2.4 Hydrologic Engineering

Attachment 2 of the RS-002 discusses the site characteristics that could affect the safe design and siting of the proposed plant or plants. Section 2.4 of the applicant's SSAR describes the hydrological setting and the data used in the applicant's safety conclusions regarding hydrology. The NRC staff's review of the SSAR covers the (1) interface of the plant with the hydrosphere, (2) hydrological causal mechanisms, (3) surface and ground water use, (4) data that forms the basis of the applicant's analysis and conclusions, (5) alternate conceptual models, (6) consideration of other site-related evaluation criteria, and (7) additional information for applications under 10 CFR Part 52.

The VEGP site is located on the southwest side of the Savannah River (SNC, 2007). The VEGP site currently hosts two nuclear power plants, VEGP Units 1 and 2. The VEGP application proposed the addition of two new nuclear power reactors, each plant fitting within the bounding parameters provided in the proposed permit, at the VEGP site (SNC, 2007).

Figure 2.4.3-1 - PMP Depth-Area-Duration Curves Near the VEGP site

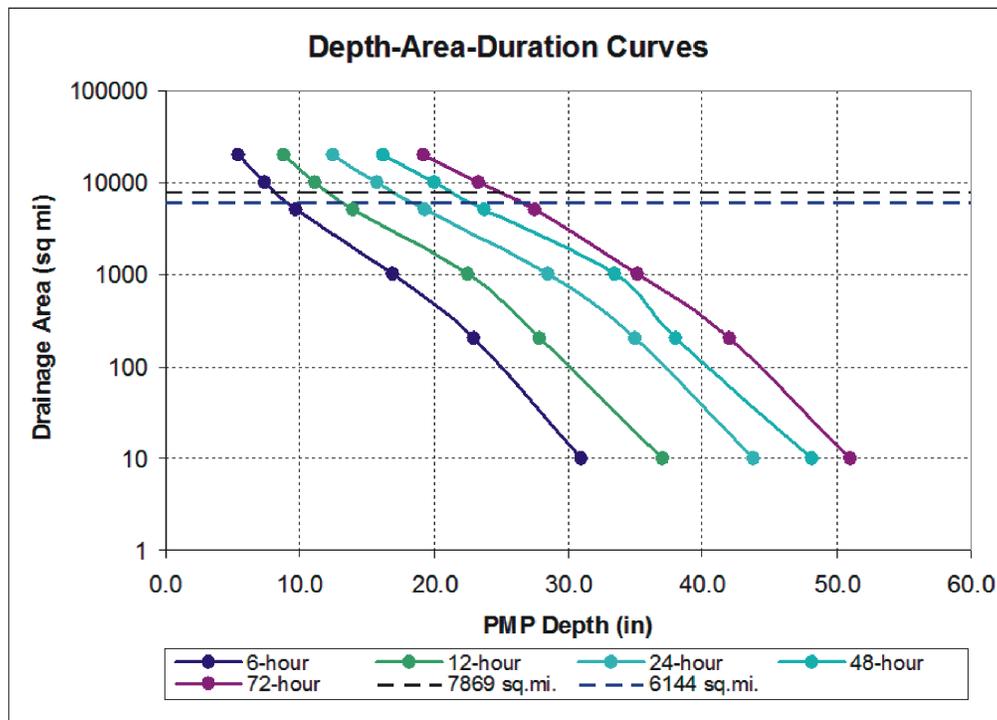
In order to verify the applicant's submittal related to PMF in the Savannah River near the VEGP site, the NRC staff carried out an independent and conservative estimate of the PMF. The NRC staff first estimated the PMP in the Savannah River Basin, as described in Hydrometeorological Report Nos. 51 and 52. The cumulative PMP depths for 6, 12, 24, 48, and 72 hours were obtained from the PMP maps in Hydrometeorological Report No. 51 for drainage areas of 10, 200, 1000, 5000, 10,000, and 20,000 square miles (Table 2.4.3-1). The NRC staff plotted a set of depth-area-duration curves for the PMP values (Figure 2.4.3-1).

Figure 2.4.4-1 - Stage hydrograph at the VEGP Site

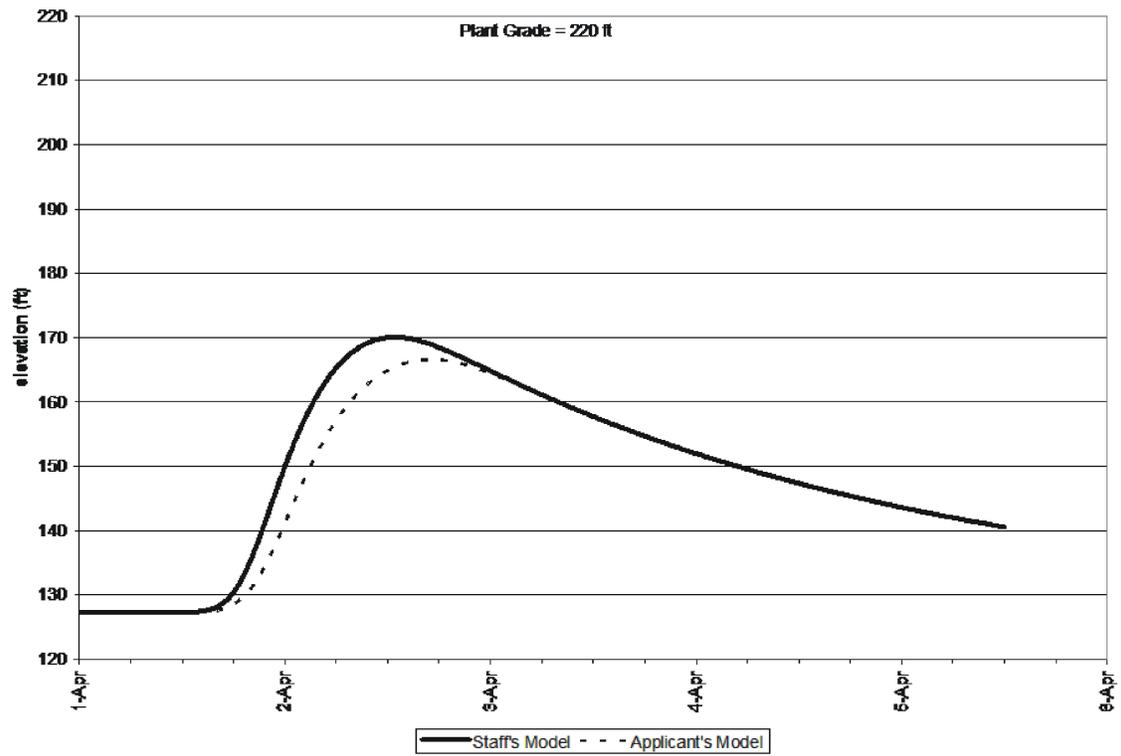
The NRC staff computed the peak discharge at the VEGP Site, after it was attenuated along the 70 miles between Thurmond Dam and the site, with approximately 2.5 million cubic feet per second. The hydrograph of water surface elevation in the Savannah River near the VEGP Site is shown in Figure 2.4.4-1 of the SER. The applicant computed the peak static water surface elevation at the VEGP site to as 166.8 feet (Southern 2007). The NRC staff's analysis, with a 50 percent increase in breach area, produced a peak water surface elevation of 170.1 feet at the site, an increase in peak flood stage of 3.3 feet.

In order to satisfy the combined effects guidance in ANS/ANSI 2.8 (1992), the maximum wave height and associated maximum wave runup were computed and added to the peak flood wave elevation. The windspeed for the site was assumed to be 50 miles per hour following the guidelines in ANS/ANSI 2.8 (1992). Based on an estimated fetch of 11.2 miles, the maximum wave height was computed to be 9.8 feet using procedures discussed in USACE (2006). In Section 2.4.4 of the SSAR, the applicant stated that the embankment slope near the site will be 2H:1V. Given this slope value and the maximum wave height, the maximum wave runup at the VEGP site was determined to be 19 feet. Combining this value with the peak static water surface elevation determined with the NRC staff's more conservative breach parameters, results in a maximum flood elevation at the VEGP site of 189.1 feet MSL. Even with a more conservative estimate of breaching parameters, the peak flood wave is 30.9 feet below the plant grade (elevation 220 feet MSL). Therefore, the NRC staff concludes that the VEGP site will not be affected by the potential failure of dams upstream of the site. The NRC staff did not apply the "no more than 5% less conservative" criterion to determine the agreement between the NRC staff's estimate of the maximum flood discharge and the corresponding water surface elevation and that of the applicant's from dam-break flooding in the Savannah River. The NRC staff only applies this criterion to compare agreement between the results obtained by the applicant and the results from the NRC staff's independent analysis when the complexity and the conservativeness of the two analyses are the same. Since the NRC staff's independent analysis of the dam-break flooding in the Savannah River is a bounding analysis that is more conservative than the analysis performed by the applicant, the NRC staff did not apply the above-mentioned rule. The NRC staff, based on their independent analysis of dam-break flooding in the Savannah River, determined that the VEGP site would not flood during the
